**Report No. 44977-UG**

**Investigation Report**

**Uganda: Private Power  
Generation (Bujagali)  
Project  
(Guarantee No. B0130-UG)**

**August 29, 2008**

**Figure 2 Lake Victoria Water Levels from January 1900 to January of 2005 (Source: Lake Victoria Basin Commission)**

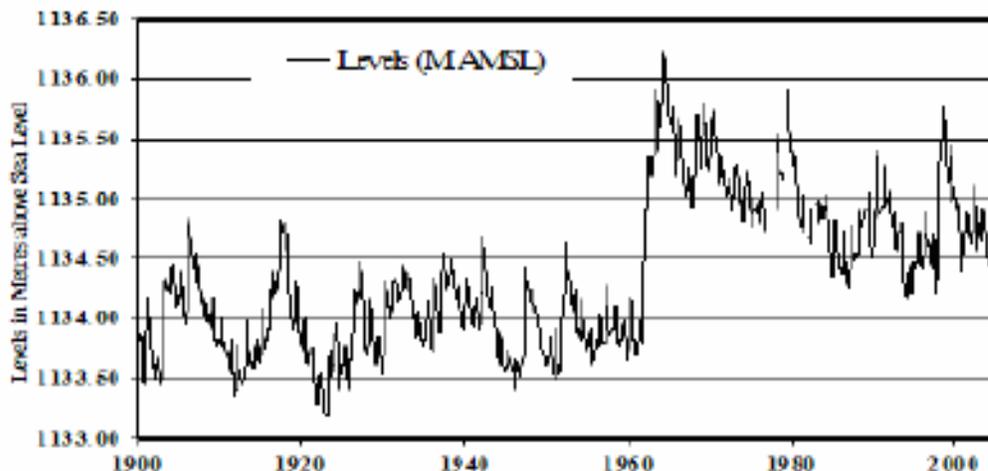
188. In general, the period before 1960 is characterized as a period of relatively low water levels. Between January 1960 and June 1964, the lake level increased about 2.5m for a total volume increase of  $170 \times 10^9 \text{m}^3$ . Between 1960/61 and 1999, Lake Victoria had much higher average inflows (around  $1200 \text{m}^3/\text{s}$ , or nearly double the average inflows in the previous period), and the Lake level rose. In contrast, starting in 2000 and until very recently, Lake levels and net inflow again decreased to a level observed before the 1960s (see Figure 2).

**Figure 3 Levels at the Lake and Outflow (2000-2005) (Lake Victoria Basin Commission, 2006)**

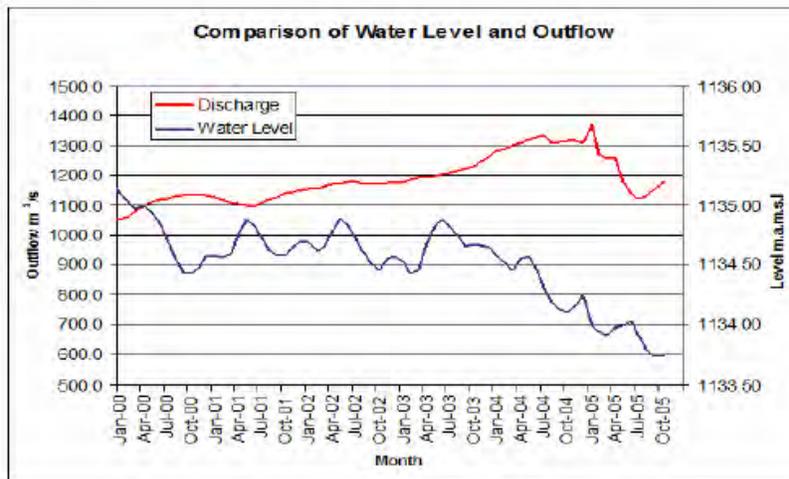
203. Figure 3 shows the lake levels and outflows for the period. It can be seen from any of the points of the curve that the outflows are above the Agreed Curve. For instance, in July 2004, when the Lake level was 1134.25 m, the flow released according to the Agreed Curve should have been 802 m<sup>3</sup>/s, while the actual outflow exceeded 1300 m<sup>3</sup>/s.

**Figure 5 Weighted Average Retail Tariff December 2000 – November 2006**

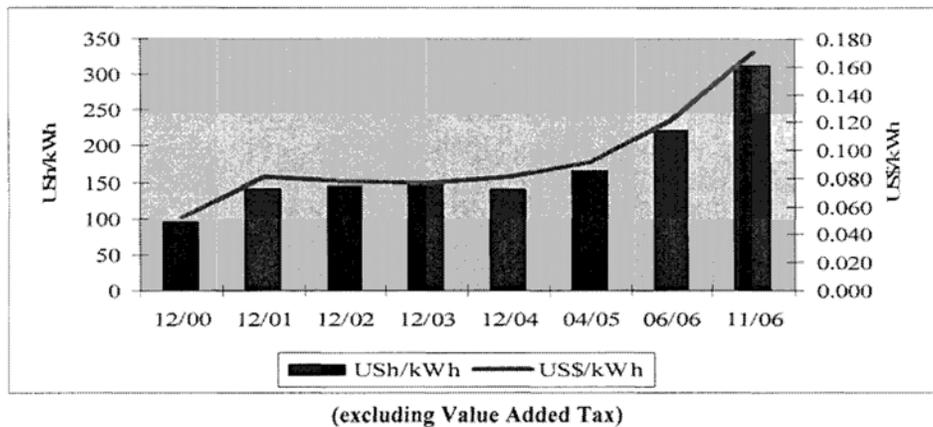
245. The PAD’s Figure 12.1 reproduced below,<sup>228</sup> illustrates how end-use customer electricity tariffs (exclusive of 18 percent Value Added Tax)<sup>229</sup> have risen since 2005, including a near doubling of 2006 average tariffs to accommodate the high cost of thermal generation. The PAD states that tariffs are expected to fall once Bujagali is commissioned “[...] and the benefits of the loss reduction and efficiency improvements [to be achieved by UMEME, the private distribution company that began work in March 2005] are realized. In real terms, under the base case scenario, the projected weighted average electricity tariff declines from the present US\$17.2c/kWh to US\$13.8c/kWh by 2011.”<sup>230</sup>

**Figure 8 Projected Electricity Tariff Path (2000-16)**

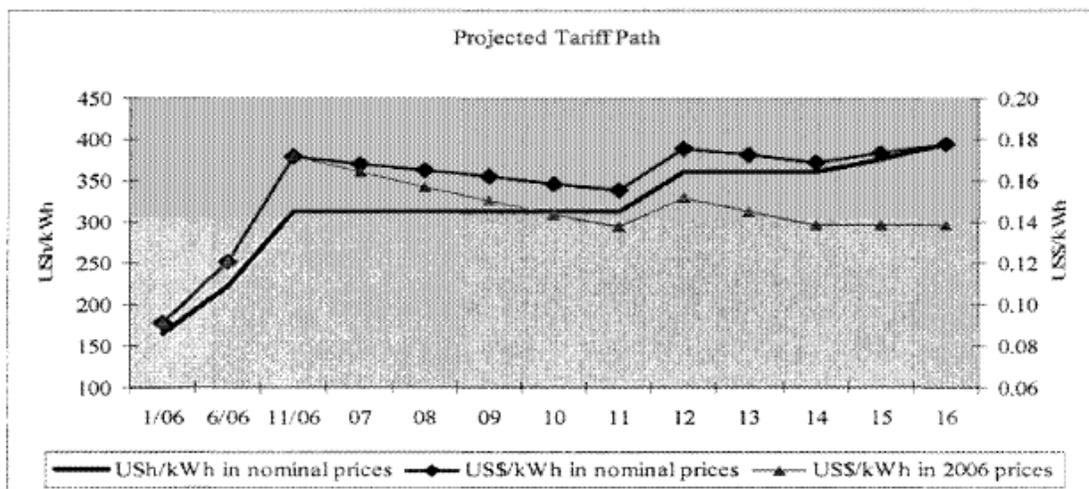
330. The PAD’s statement simply asserts that the Economic Study shows that the tariff may drop by up to 10 percent, without qualifying the statement in light of the increases in EPC and transmission costs after the Economic Study was prepared and that were recorded in the PAD (but before it was finalised). The issue of electricity tariffs and affordability is of such high importance to the people and communities. **The Panel finds that, in order to comply with the requirements of OP 10.04, the PAD should have qualified its statement about the projected drop in tariffs to take into account the impact of EPC and transmission cost increases.**<sup>315</sup>
331. The PAD presents its own estimates of the projected levels of the weighted average retail tariff path, based on a different and presumably later Economic Study, shown in Figure 12.2 (below) :

384. Figure 3 and Figure 12.2 in the PAD depict projected revenue requirements and the projected tariff path to 2016. These graphs indicate the scale of the challenge, and the scale of expected revenue shortfalls. The PAD suggests that “*The projected revenue requirements and tariffs converge by the time the proposed project comes on line in 2011. Electricity tariffs would be fully cost reflective by then and subsidies would be removed, except for duty exemptions on generation fuel and transmission investments.*”<sup>382</sup> It estimates Government support to power utilities at US\$734 million for 2005-2011 and US\$85 million for 2012-16. Over the period 2005-16, the government is projected to collect net revues of \$US217 million: “*The power sector will be a drain on the Treasury until the proposed project is commissioned but a net contributor after.*”<sup>383</sup>
